Re: Request for minor variation 450 Central Way DRV12-01340

**CONSULTING ARBORIST MULTIFAMILY and
LSM (GRADING PERMIT) REVIEW CHECKLIST**

Permit Number: DRV12-01340
Address: 452 Central Way
First Review Due By:
Assigned Planner: Jon Regala
Assigned Public Works Reviewer: Rob Jammerman
Routing Type: Regular

Alexan Kirkland Average Setback

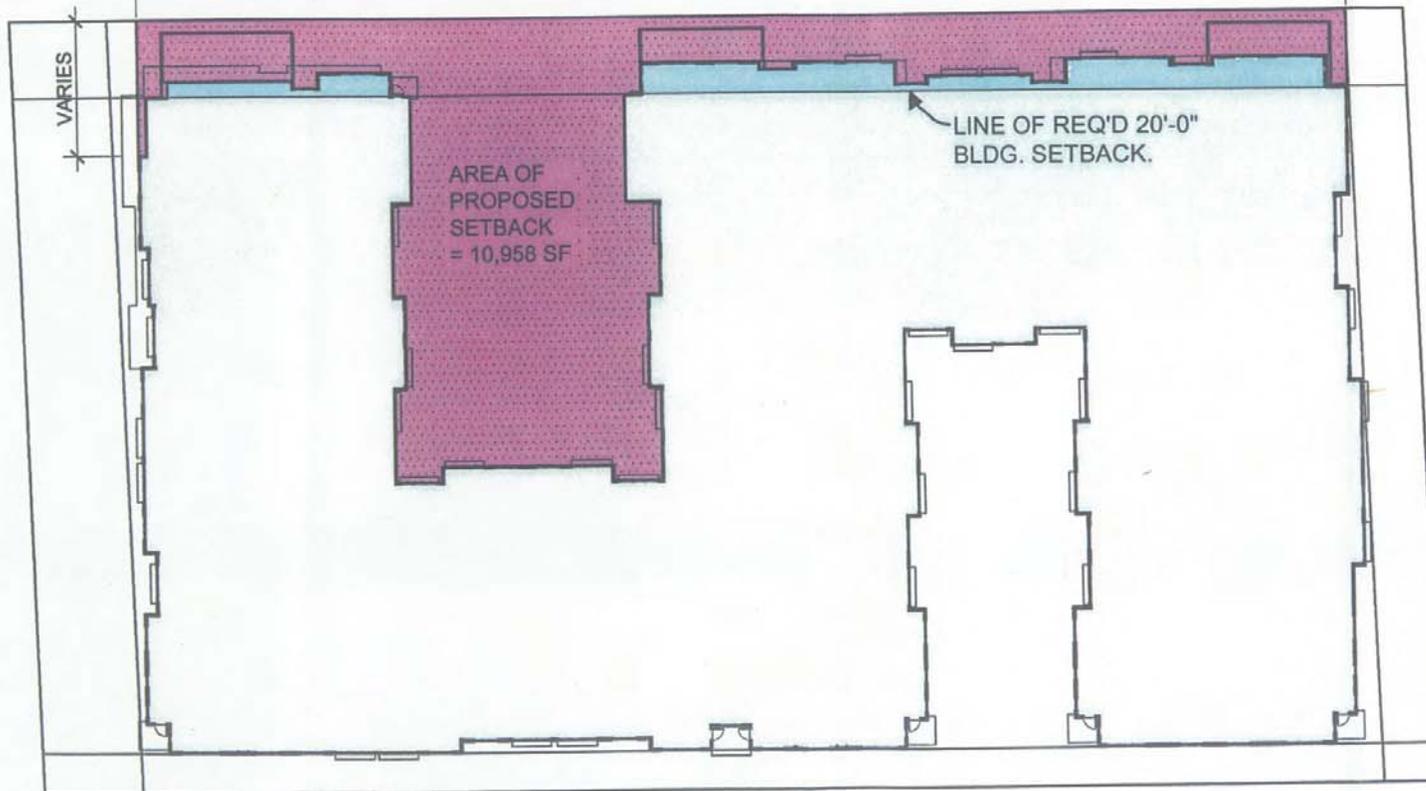
AREA OF SETBACK (10,958 S.F.) / LENGTH 312'-10" (312.83FT) = 35.03 FT

35'-0"
AVERAGE
SETBACK

-  AREA OF REQUESTED UPPER LEVEL DEPARTURE
-  AREA OF BUILDING SETBACK

Vegetated buffer from south with tree #1 (far left) and arrows identifying tree #13 and #23 (far right)

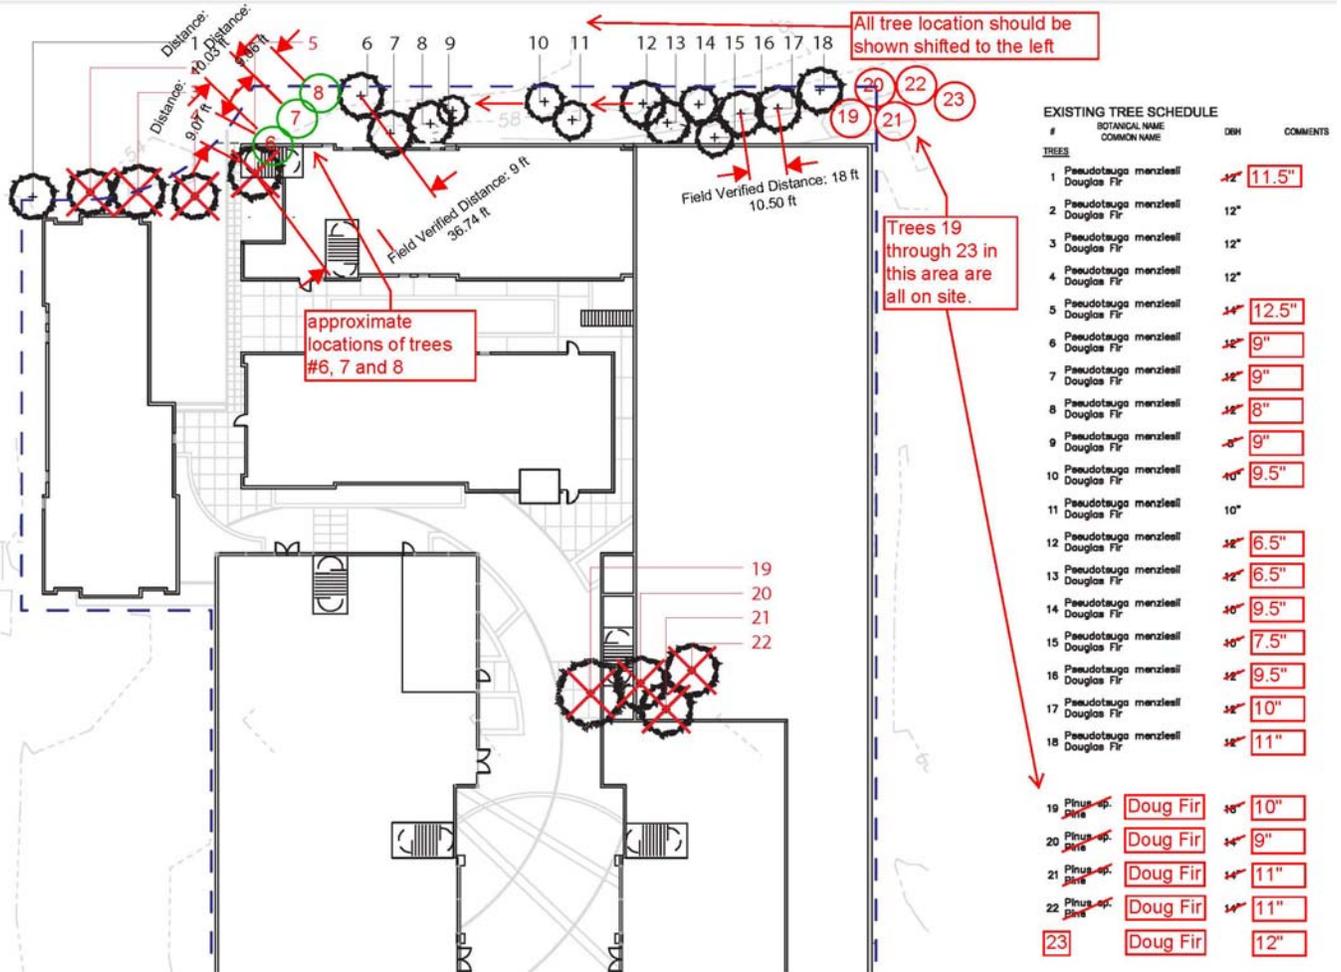
The DBH measurements are incorrect for 13 of 22 trees. Five trees do not appear on the plans but are on-site (#23 through #28). Trees #6 through #18 are located on the plans incorrectly. Field observations and measurements prove that they are approximately 9 feet from one another. All of these inaccuracies add challenges to analyzing how well the proposal preserves the existing vegetative buffer specifically in the accuracy of survey data and the horizontal location of the improvements.

I have no objection to a 6 foot limit of disturbance. Trees #13 should be removed due to its live canopy of approximately 10% and a 3 inch ivy vine (dead) distorting the trunk taper. See image below.

The vegetative buffer will remain mostly intact if tree protection measures are maintained through construction per City of Kirkland standards. Enhancing the buffer is strongly recommended for permit approval due to the spaces created via tree removal. Also, the remaining Douglas fir trees will grow thin below the roof height due to a lack of sunlight. This natural process will result in a substandard buffer for the residents to the north. Part of the buffer enhancement should include taller shrubs and understory canopy tree species to maintain a vegetative buffer when the remaining Douglas fir trees grow thin in approximately 10 to 20 years.
